**1958 Agreement – Consideration of draft amendments
to existing Regulations submitted by GRSG****Proposal for the 01 series of amendments to Regulation
No. 110 (CNG equipment)****Submitted by the Working Party on General Safety Provisions***

The text reproduced below was adopted by the Working Party on General Safety Provisions (GRSG) at its 102nd session to clarify the general test provisions in the Regulation, mainly those on fuel rail. It is based on document ECE/TRANS/WP.29/GRSG/2012/9, as amended by Annex VII to the report (ECE/TRANS/WP.29/GRSG/81, Para 24). It is submitted to the World Forum for Harmonization of Vehicle Regulations (WP.29) and to the Administrative Committee AC.1 for consideration.

Model B

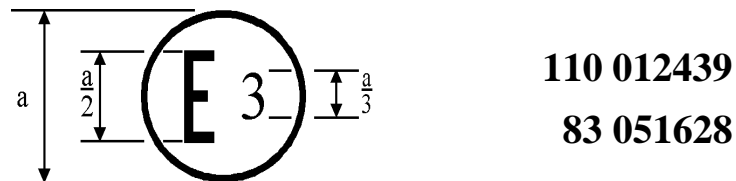
Annex 2C, models A and B, the figure and the text below the figure, amend to read:

The above approval mark affixed to a vehicle shows that the vehicle has, with regard to the installation of CNG system for the use of CNG for propulsion, been approved in Italy (E3), pursuant to Regulation No. 110 under approval number 012439. The first two digits of the approval number indicate that at the date the approval was granted in accordance with the requirements of Regulation No. 110 as amended by the 01 series of amendments and that Regulation No. 83 included the 05 series of amendments."
